July 16, 2010 (revised from July 8, 2010)

Re: Revised Proposal for Temporary Leachate Collection Wells 12th Street Landfill Operable Unit No. 4

Allied Paper, Inc./Portage Creek/Kalamazoo River Superfund Site

SUBGRADE CONTOUR PLAN

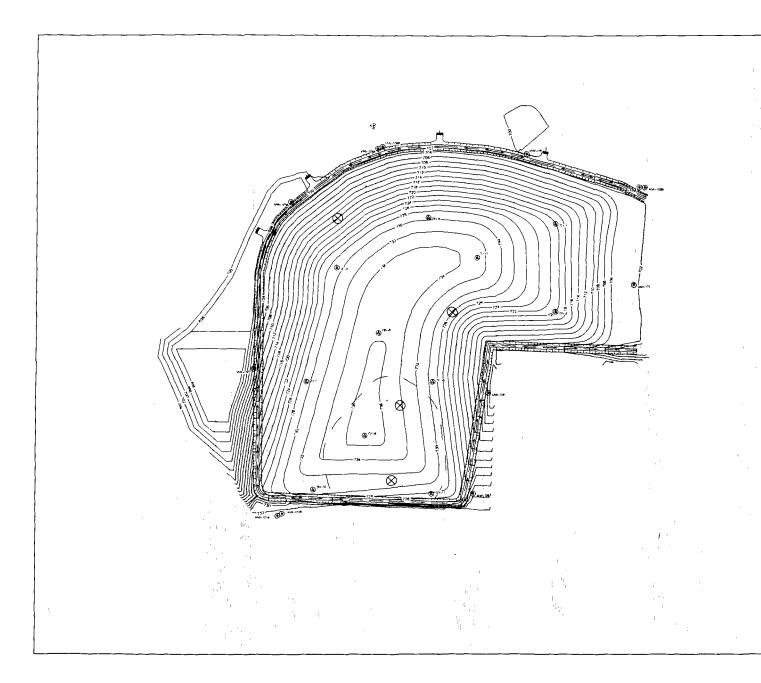
In lieu of digging test pits, CRA is proposing to initially install at least four temporary leachate collection wells in the approximate locations presented on the attached figure. Two temporary leachate collection wells will be installed within the delineated area described as the "Approximate Location of Construction Debris (Geraghty and Miller, 1994a)". A third leachate collection well will be installed directly north of the delineated construction debris area, at the approximate bend in the landfill sideslope as it proceeds around the northwest corner of the adjacent Michigan Department of Natural Resources and Environment (MDNRE) property. During ongoing landfill excavation and regrading activities in this area, construction debris has been encountered and a leachate seep has been observed. The proposed well would be installed near the top of the existing slope in order to intercept the leachate before it potentially leaves the

In addition to the three potential leachate collection wells within the identified locations of construction debris, one other temporary leachate collection well will be installed along the northwest side of the 12th Street Landfill. At present, there is a leachate seep emanating from the northwest sideslope approximately midway between former monitoring wells MW-2 and MW-3. A temporary leachate collection well will be installed above the observed seep area, near the top of the current landfill sideslope. Slope excavation activities have been completed around to the west side of the landfill, adjacent to the asphalt plant property, and no construction debris was observed nor have any additional seeps been identified in this area.

The proposed temporary leachate collection wells will be drilled using appropriately sized hollow stem augers such that 4-inch diameter wells screens and casing may be installed. The intended depth will be approximately 20 feet within the construction debris area, or until the interface between high permeability construction debris and low permeability paper residuals or clay is observed. It is expected that the presence of construction debris may prevent drilling to the bottom of the previously placed construction debris (i.e., may hit refusal). If more than two attempts are required at any particular location, then the well will be placed above the depth of refusal, assuming perched water has been encountered. CRA and Weyerhaeuser will consider additional leachate collection wells in the known construction debris area if the perched water table is not adequately addressed by the initial leachate collection wells. The other two temporary leachate collection wells to the north and northwest may be shallower in depth, but will also be installed to the observed interface. If no construction debris or perched water is encountered, then a temporary leachate collection well will not be installed at that particular location.
